VILLAGE OF EMPIRE - SITE PLAN REVIEW APPLICATION

**Site Plan Review  
Case #SPR-2024-01**

### **CHERRY REPUBLIC EXPANSION, EMPIRE FACILITY**

C100

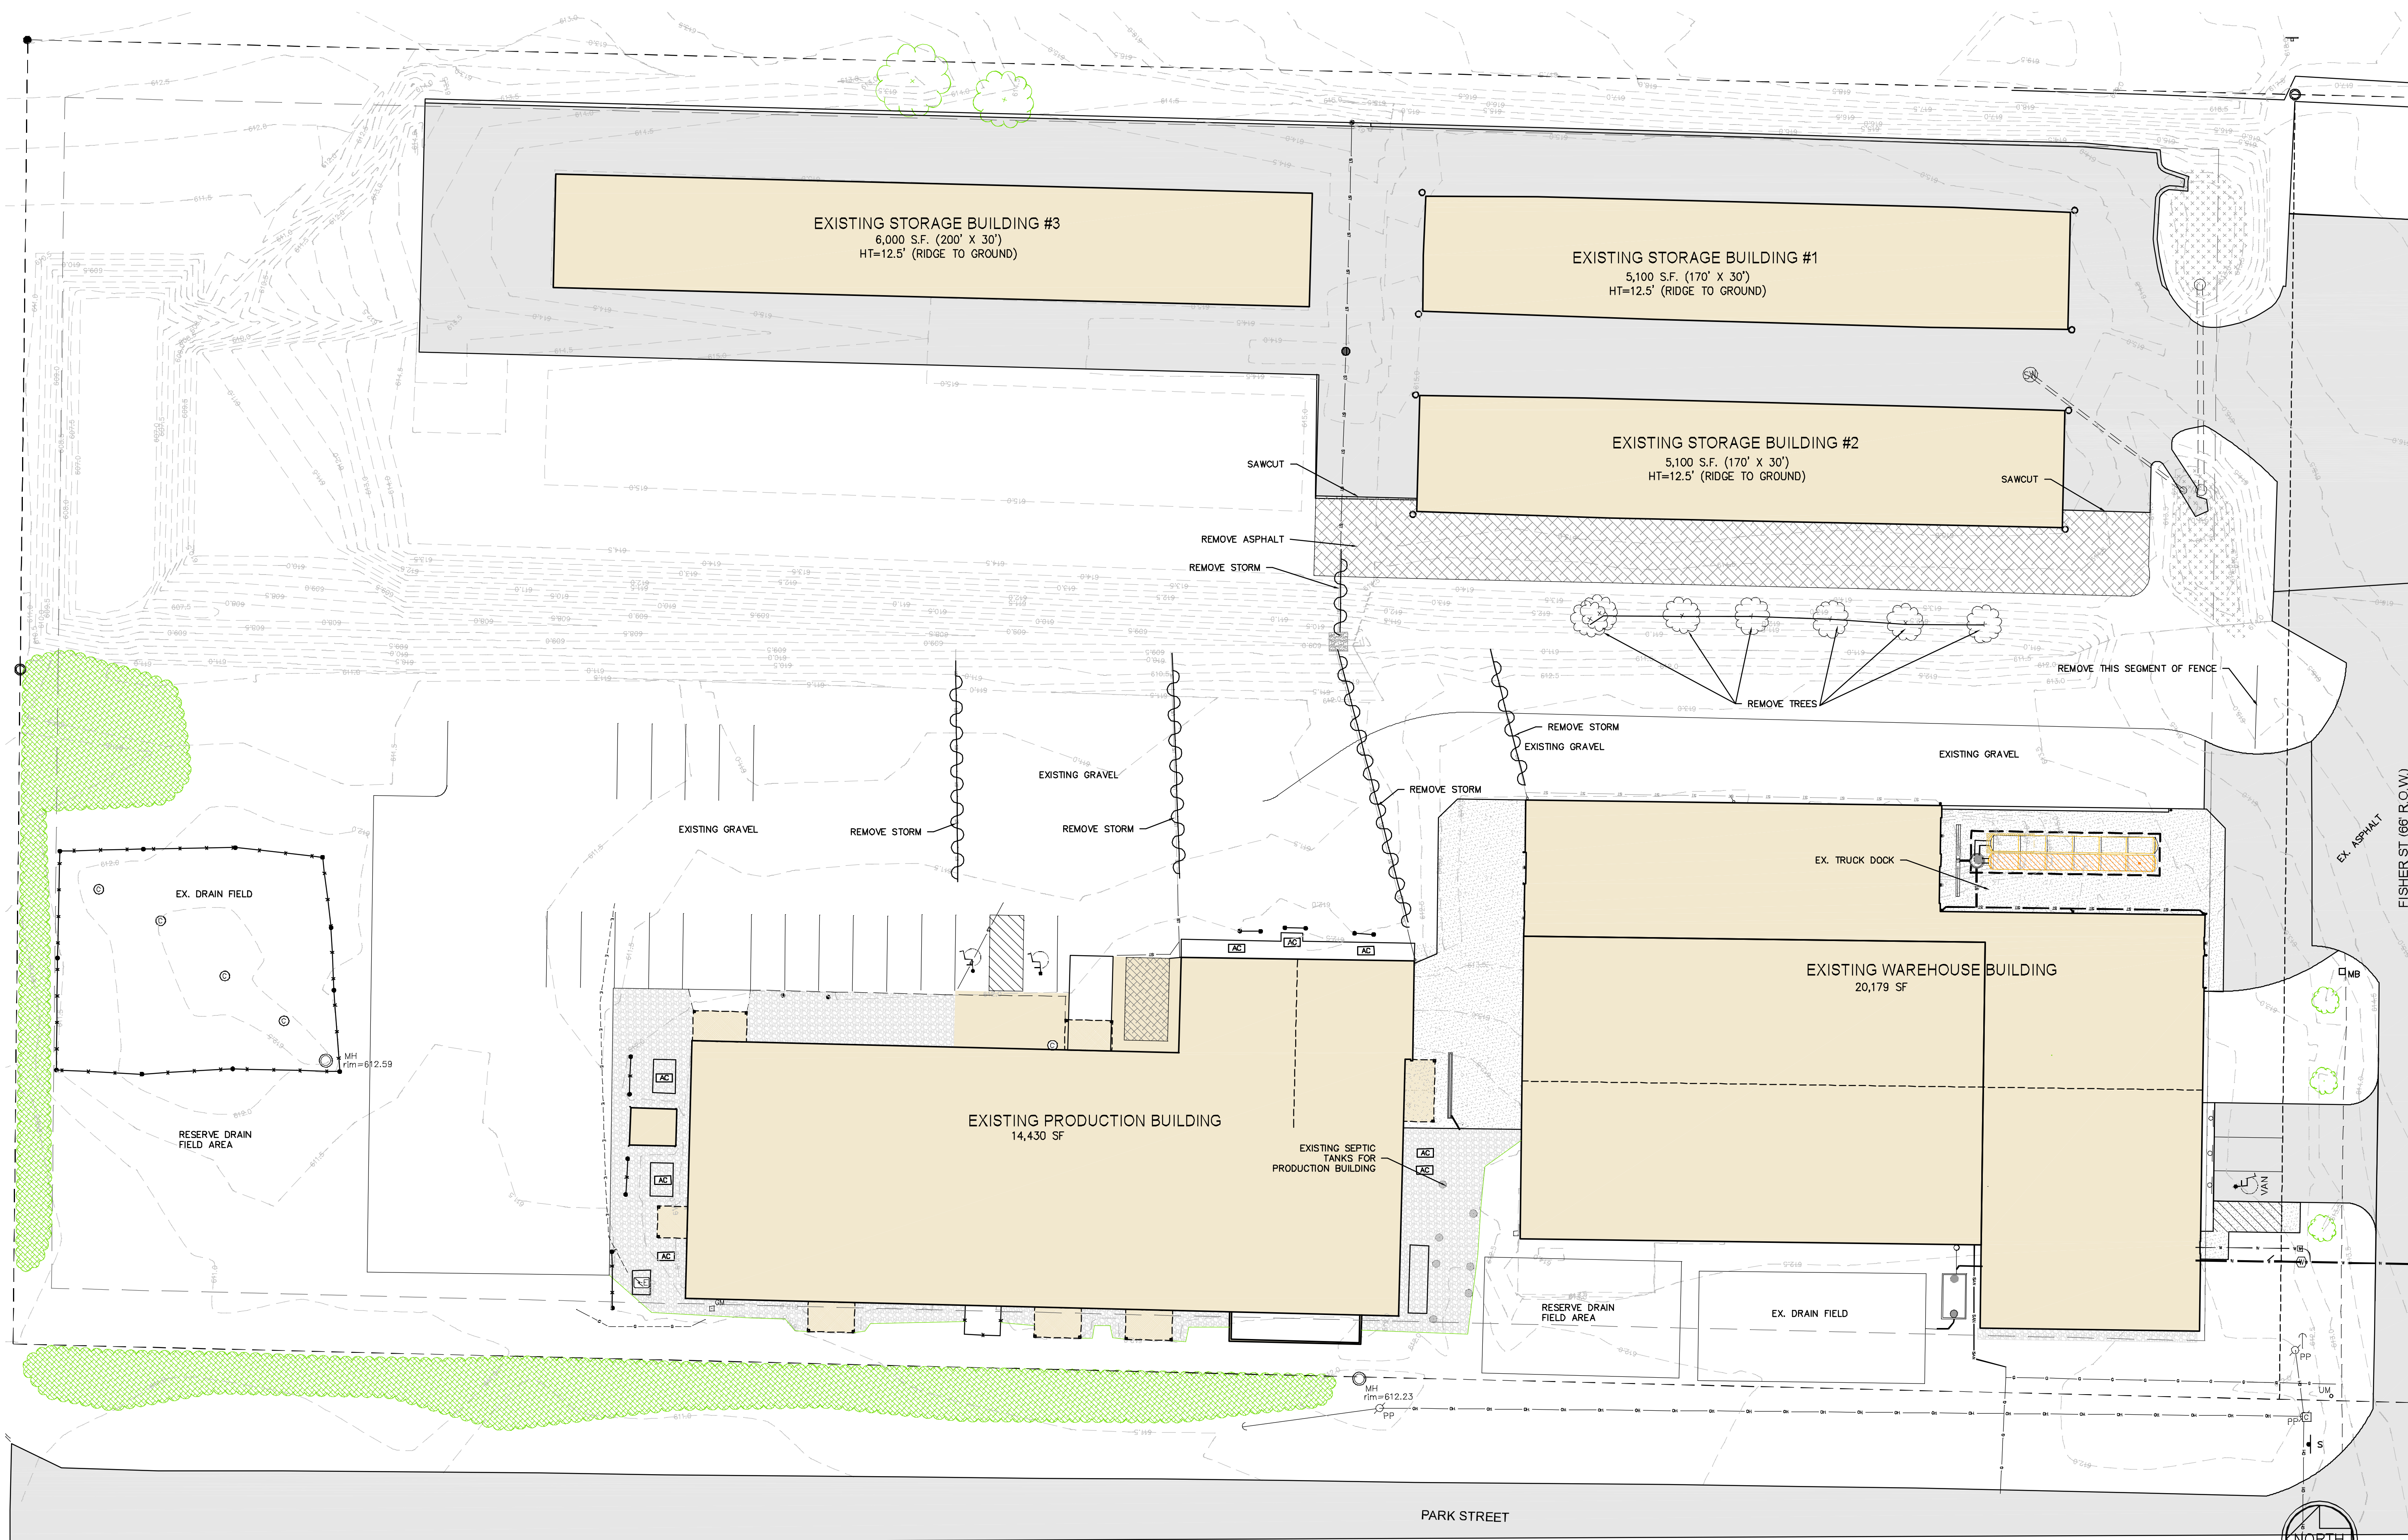
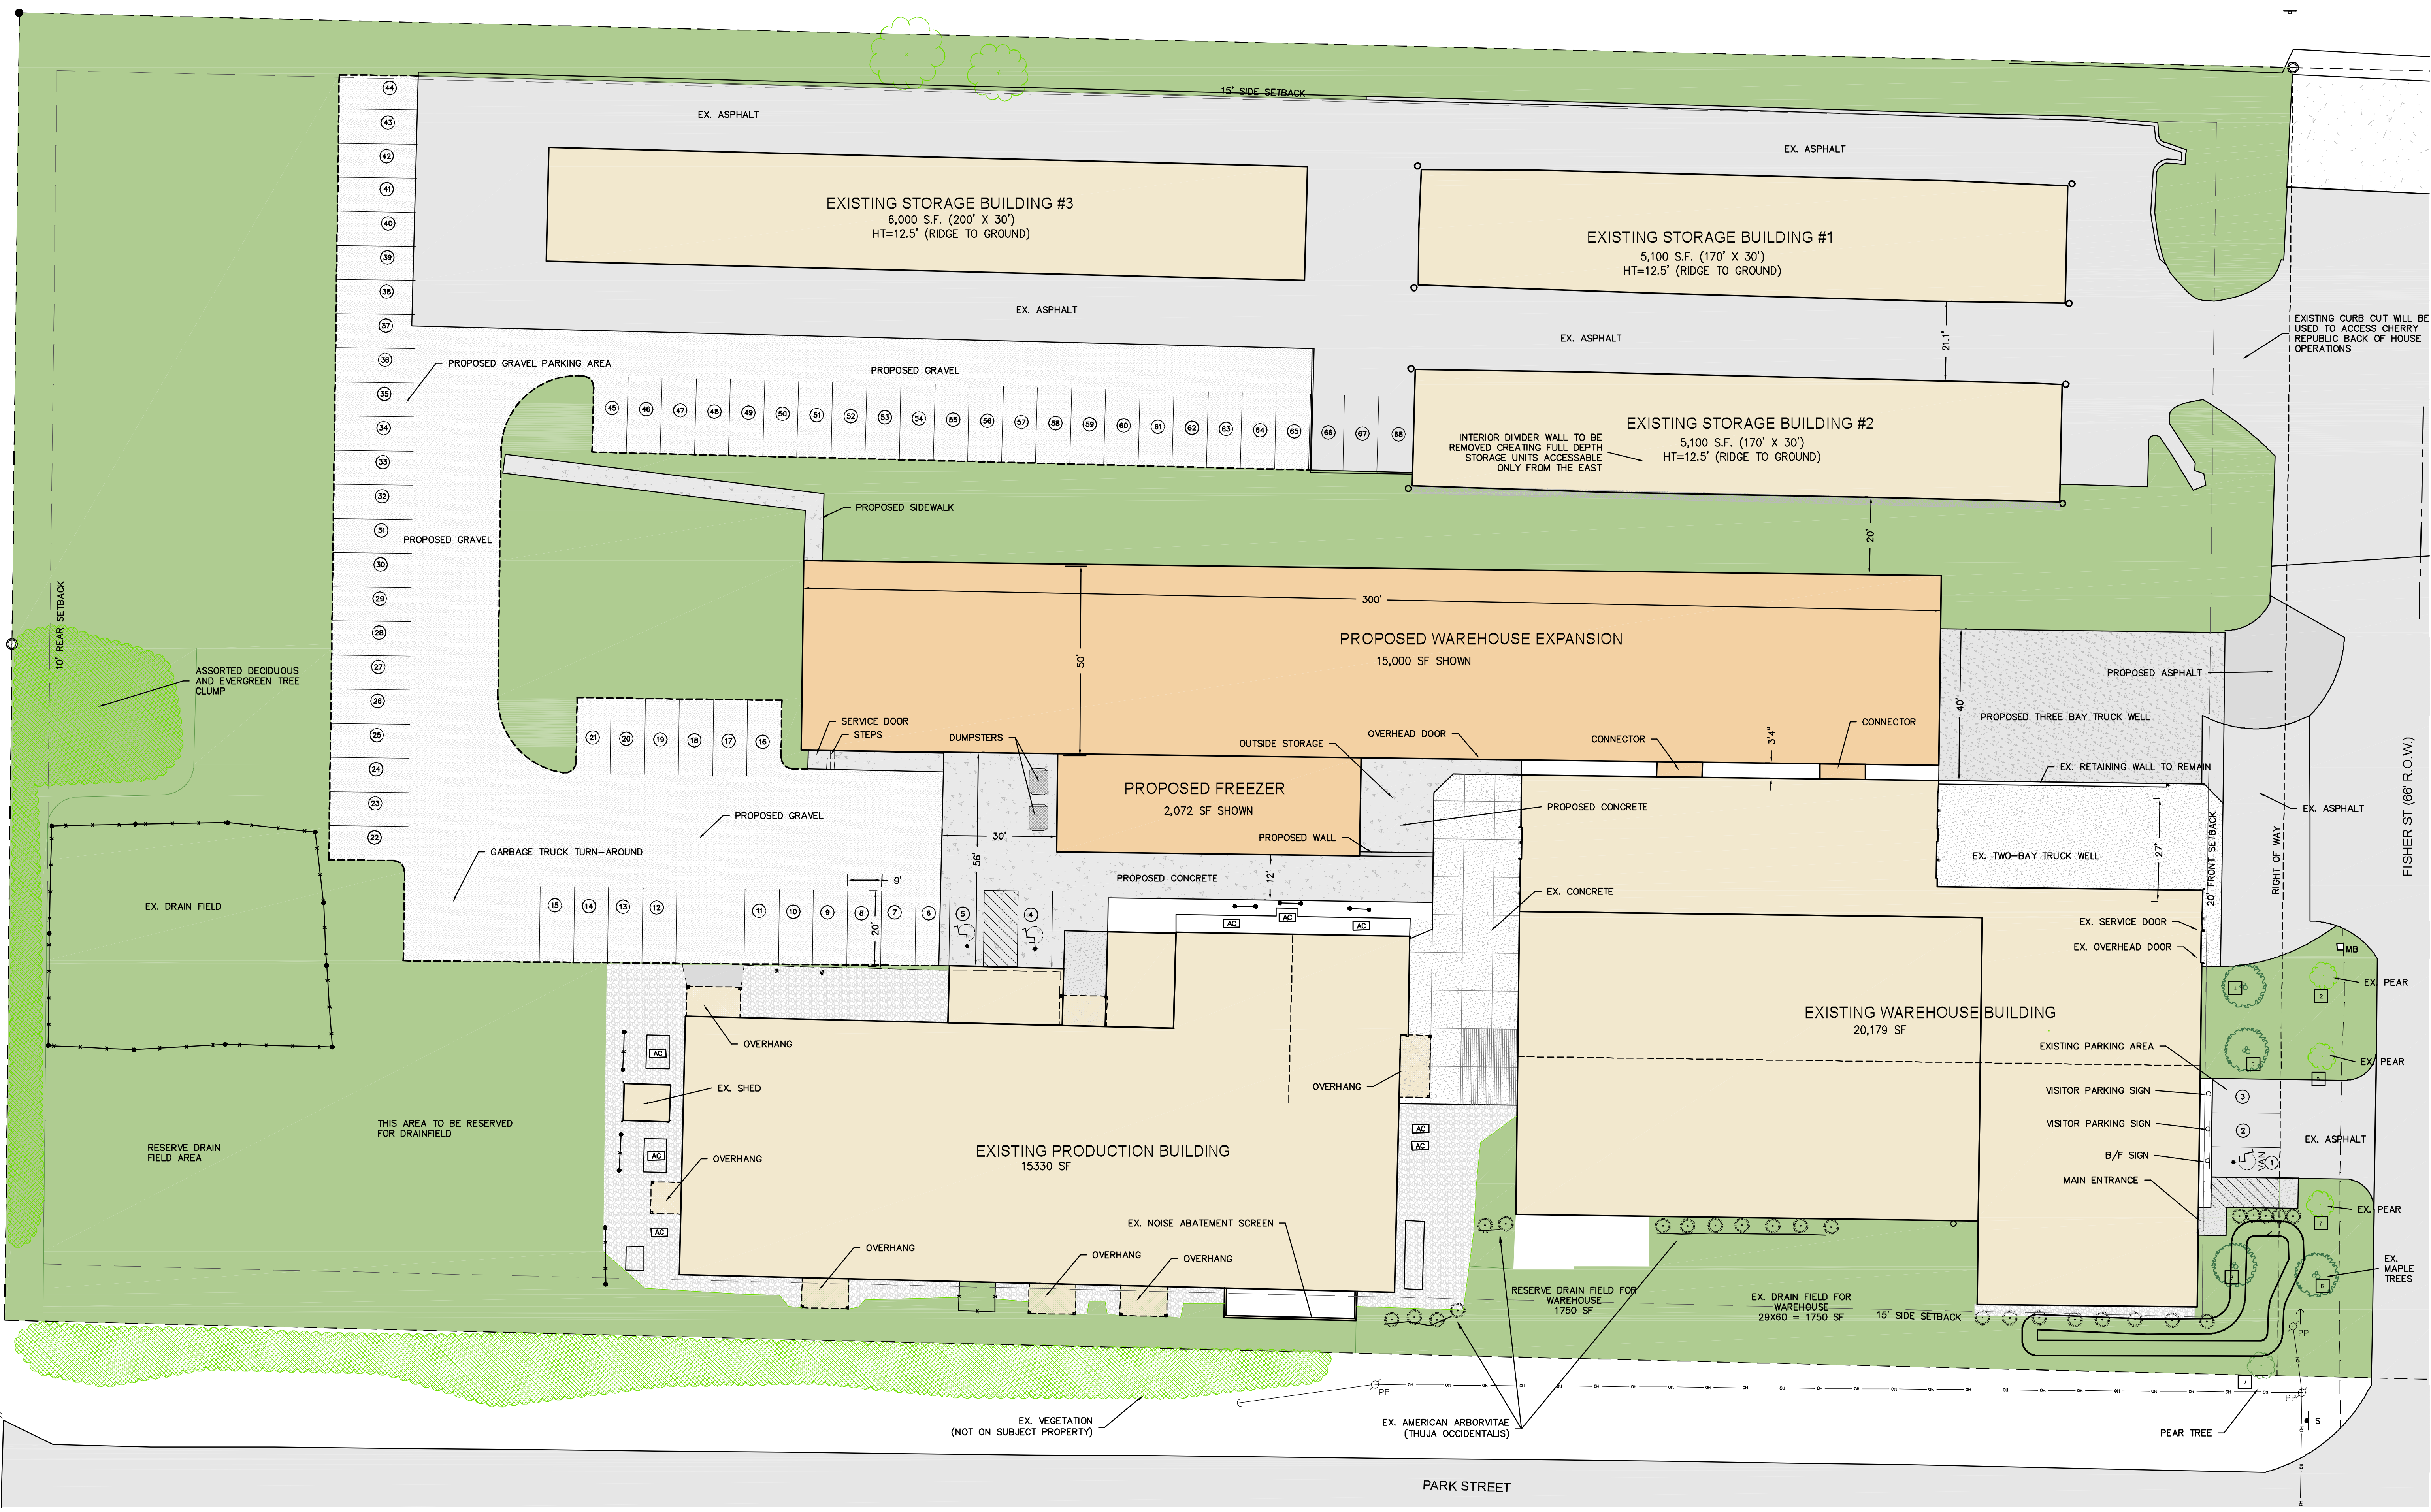
**Provided on Application and Site Plan | C100**

**Provided on Site Plan | C100**

**Provided on Site Plan | C100**

**Provided on Site Plan | C100**

**Provided on Site Plan | C100 and C102**
